SUBJECT: **ADDENDUM # 2**

PROJECT TITLE: West Campus Development – Phase 2
Norwalk Community College
Norwalk, Connecticut

PROJECT NO.: **BI-CTC-406**

BID OPENING	**1:00 P.M.**	**August 12, 2009**
ADDENDUM NUMBER TWO	**DATE OF ADDENDUM**	**July 30, 2009**

SK-A2.00-B

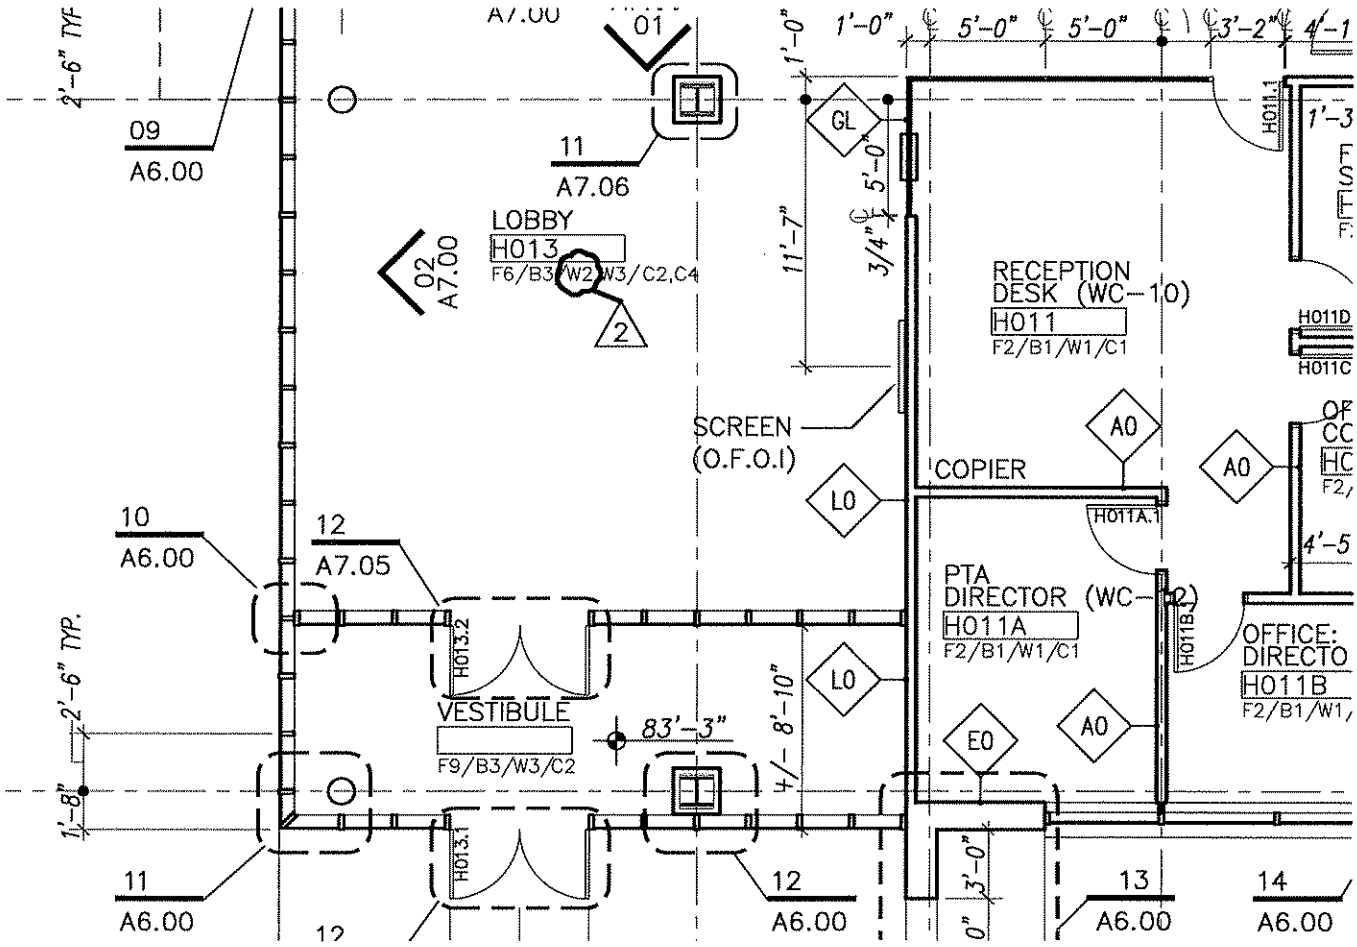
On Drawing A2.00, on Ground Floor Plan: New Building, in Lobby/H013, change wall finish to "W2" as indicated on attached Sketch SK-A2.00-B dated 30 July 2009.

06-A DETAIL @ EXTRUDED ALUM. FILLER
1 1/2" = 1'-0 "

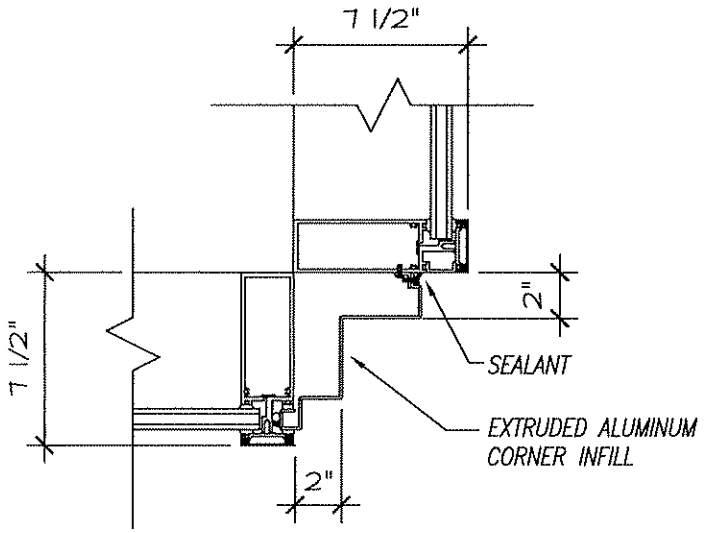
On Drawing A6.00, on Plan Details/Exterior Details, add new Detail 06-A as indicated on attached Sketch SK-A6.00-A dated 30 July 2009.

5. Q. *Details 06/A6.00 & 09/A6.00 Extruded aluminum infill by window manufacturer: What is the infill? Can more details re: caps/inserts for curtain walls be provided?*

A. See attached Sketch SK-A6.00-A.

08 DETAIL PLAN SECTION: TYP TILE OUTSIDE CORNERS
6" = 1'-0"

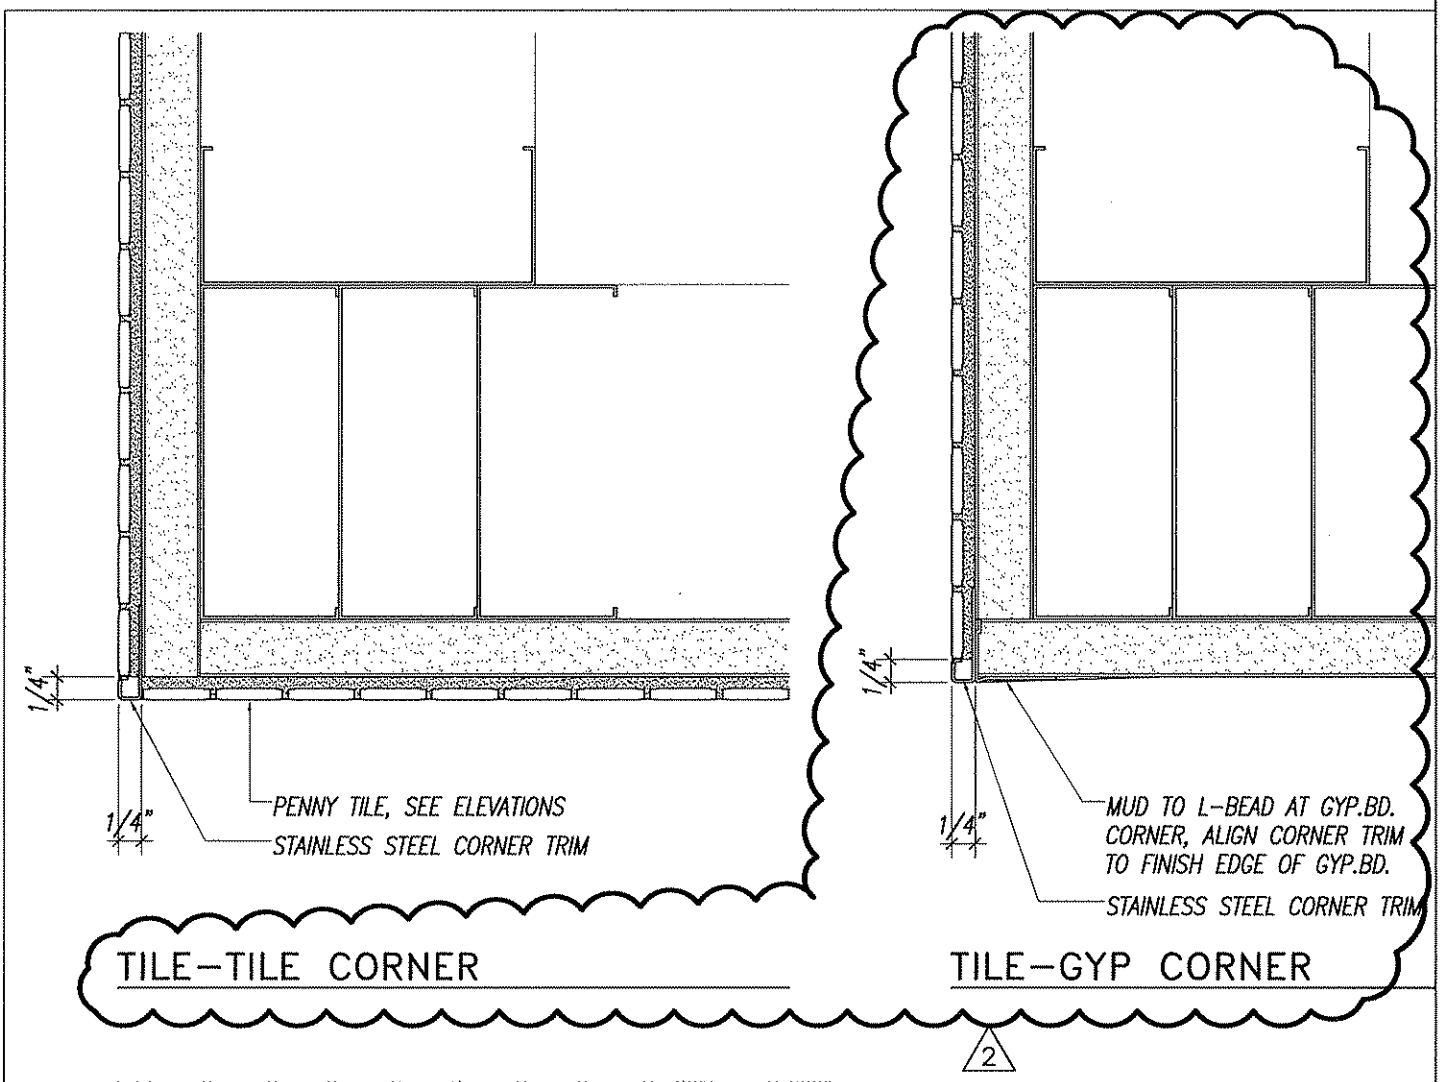
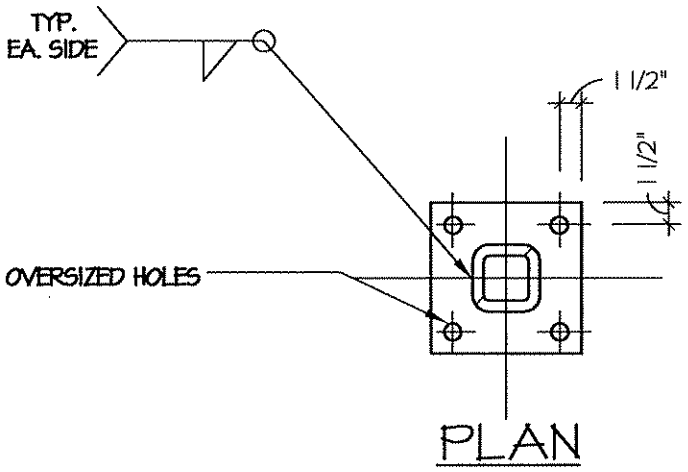
On Drawing A7.05, on Interior Details, revise Detail 08 as indicated on attached Sketch SK-A7.05-A dated 30 July 2009.

SK-S301-A

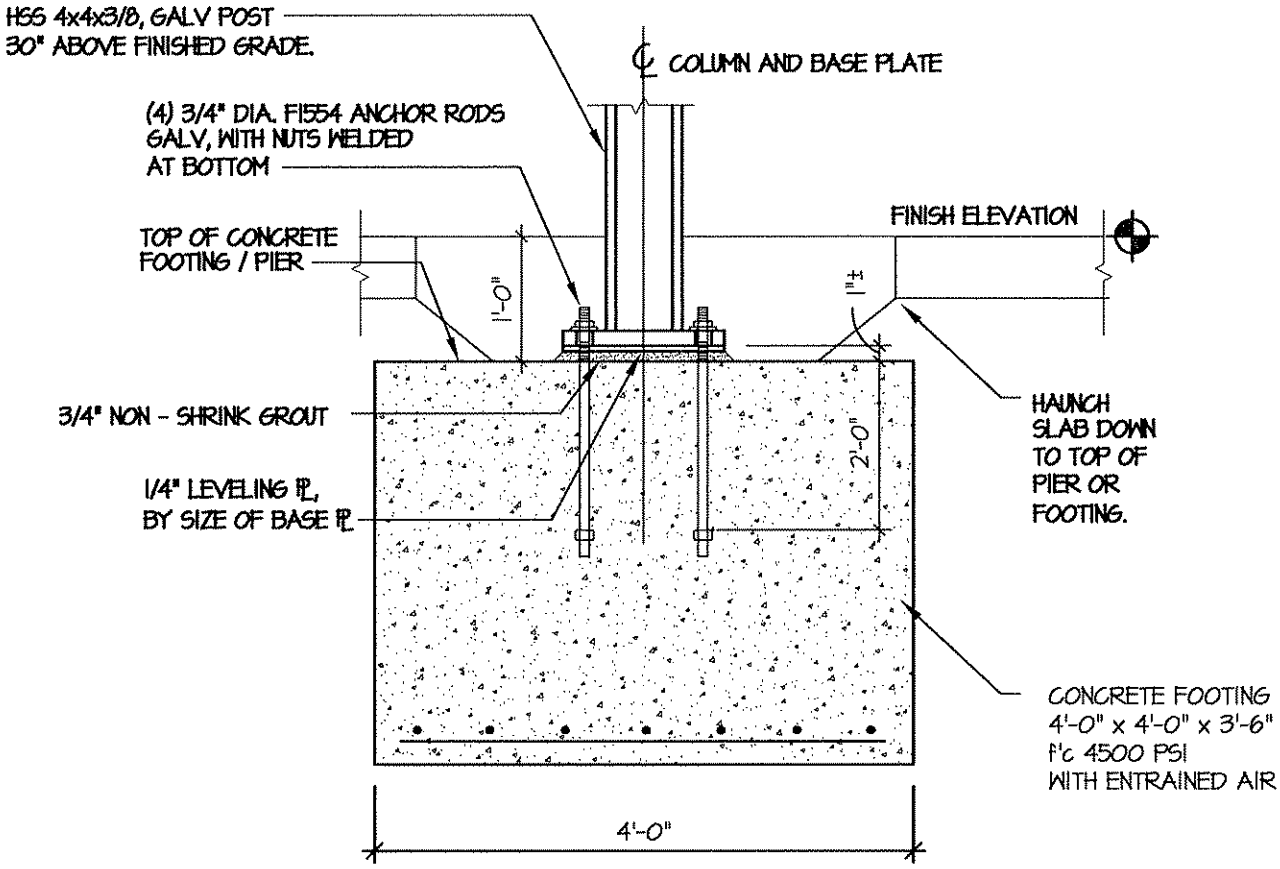
On Drawing S3.01, on Structural Foundation Details, add new Details of Artwork Foundation as indicated on attached Sketch SK-S301-A dated 30 July 2009.

SK-E001-A

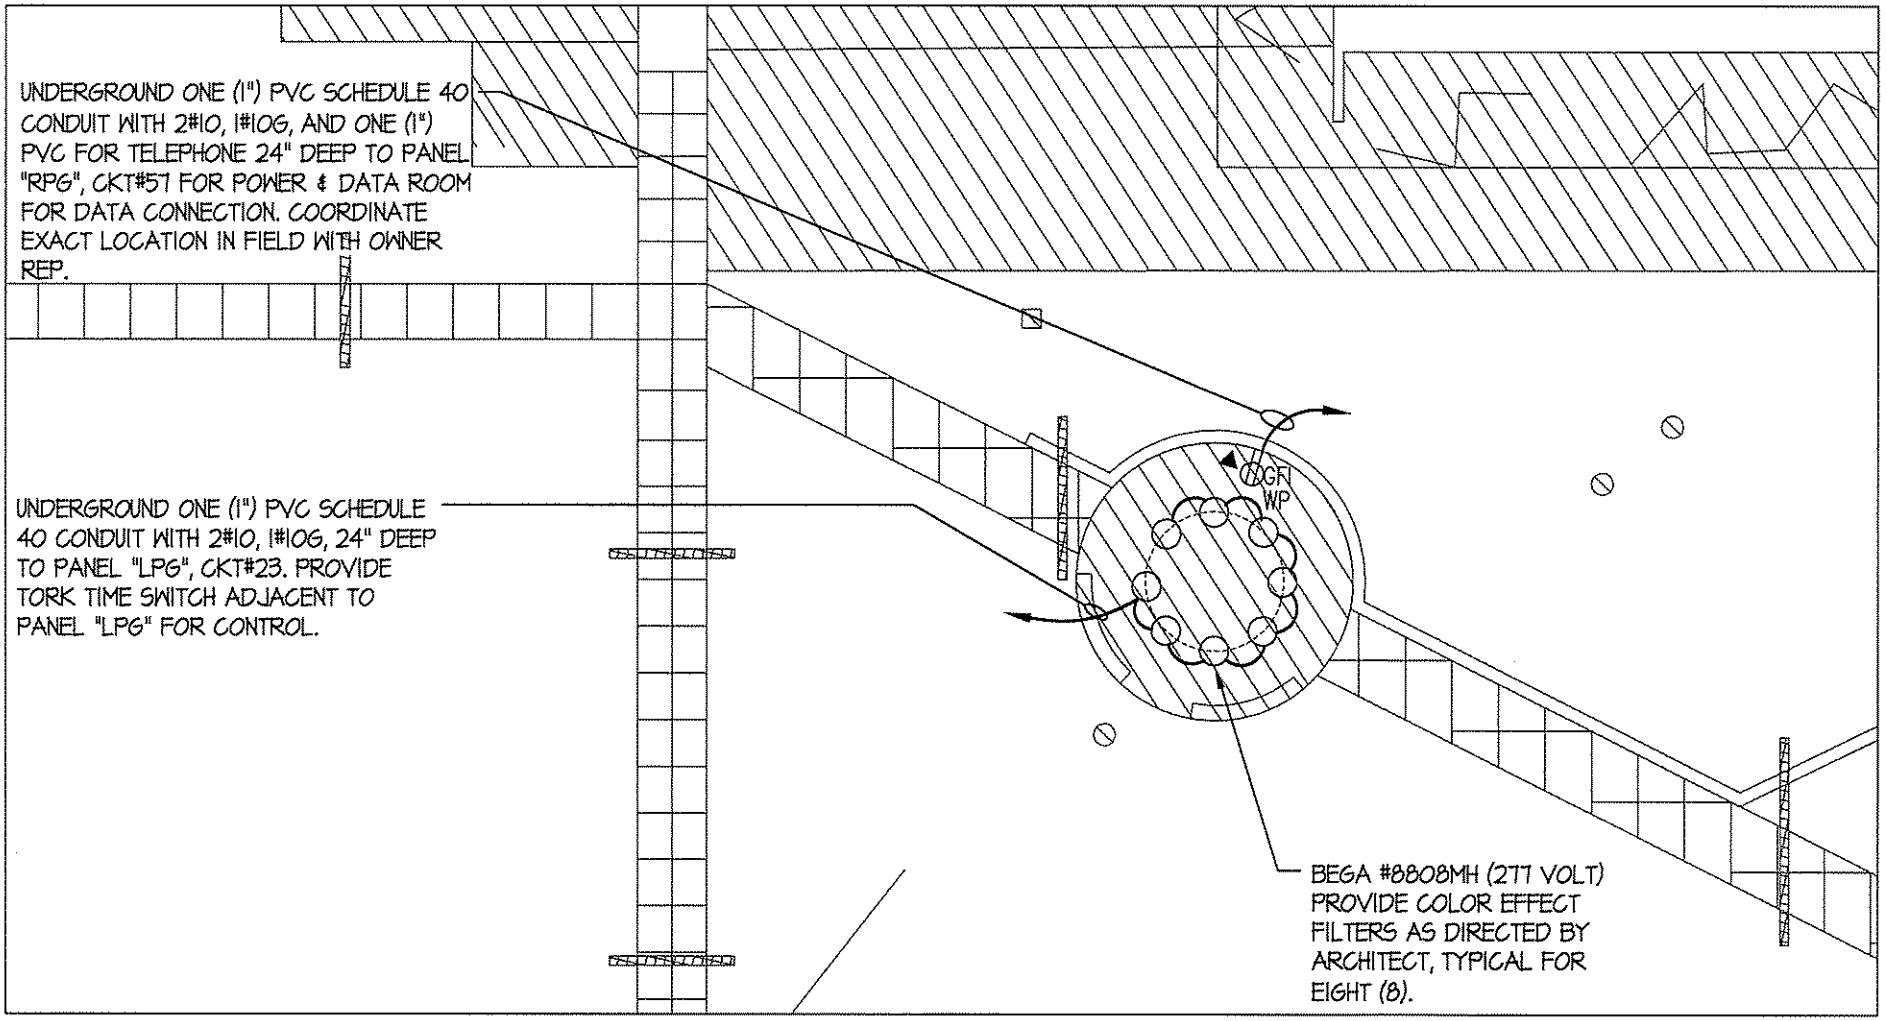
On Drawing E001, on Electrical Site Plan, add Artwork electrical information as indicated on attached Sketch SK-E001-A dated 30 July 2009.

SK-L1.00-A

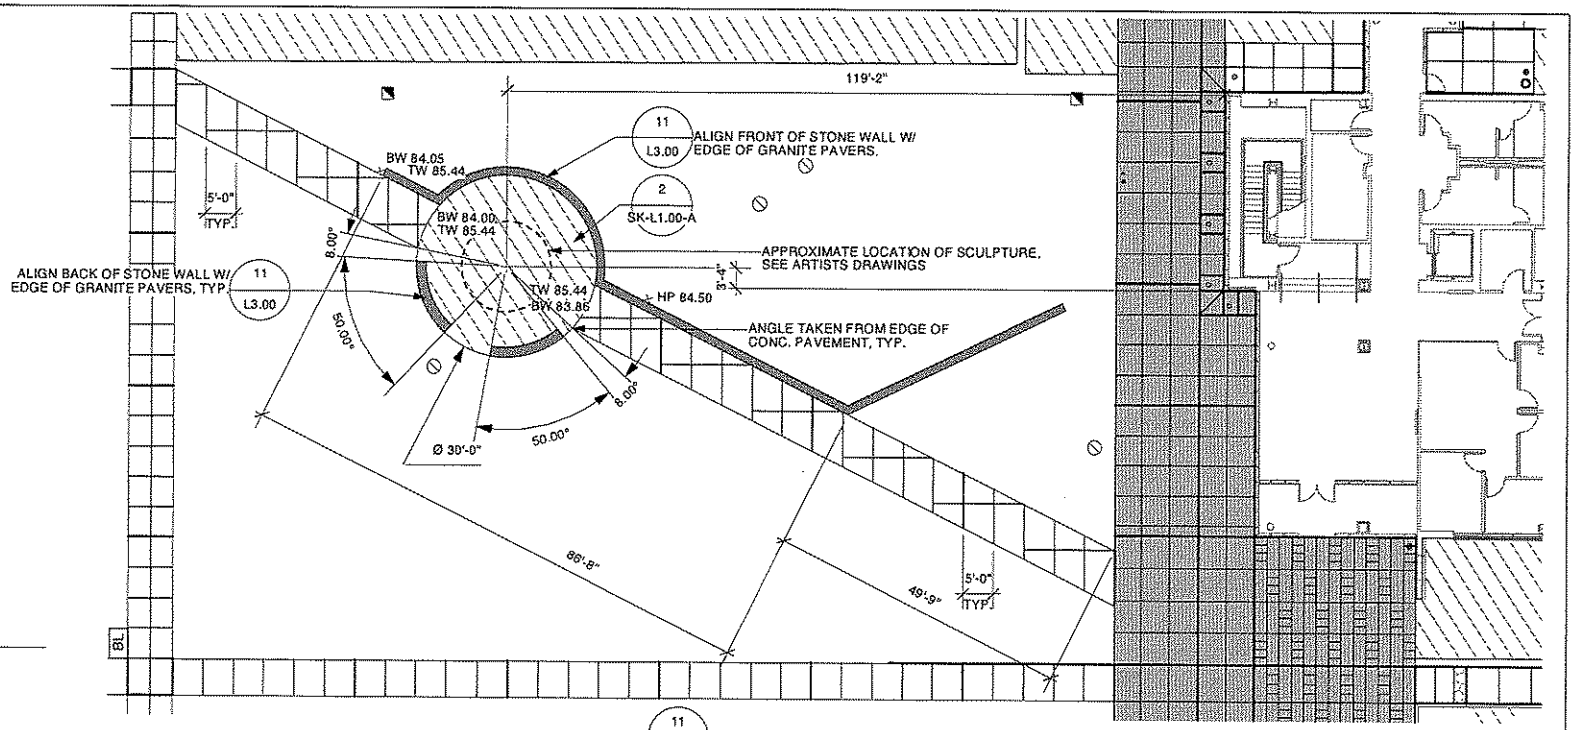
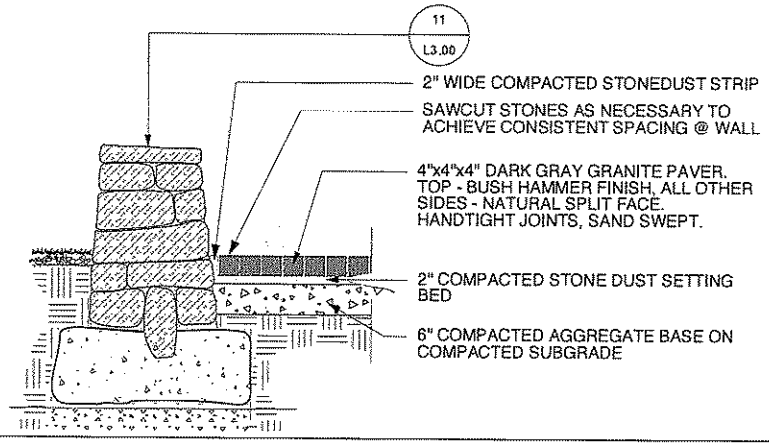
On Drawing L1.00, add Art Piece Layout and Granite Cobble Paving Detail as indicated on attached Sketch SK-L1.00-A dated 30 July 2009.

SK-A2.00-A

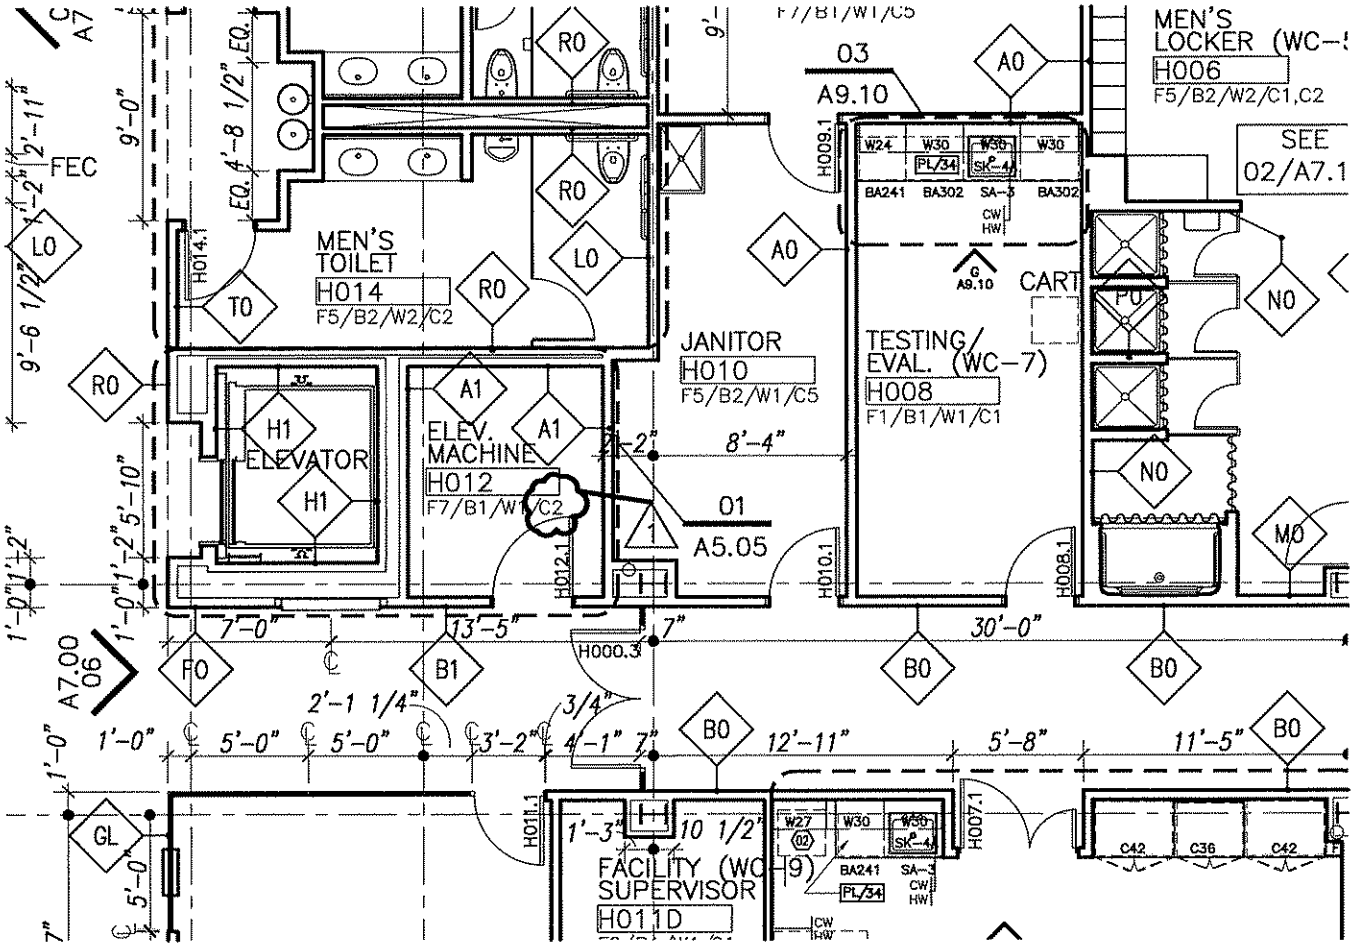
1. SK-A2.00-A "Ground Floor Addition Plan"
2. SK-A7.40-A "Type M Plaque Sign"
3. SK-A8.03-A "Ground Floor Flooring Pattern-New Building"
4. SK-M3.06-A "Gas Train Piping Diagram"
5. SK-M3.06-B "#2 Oil Piping Diagram"
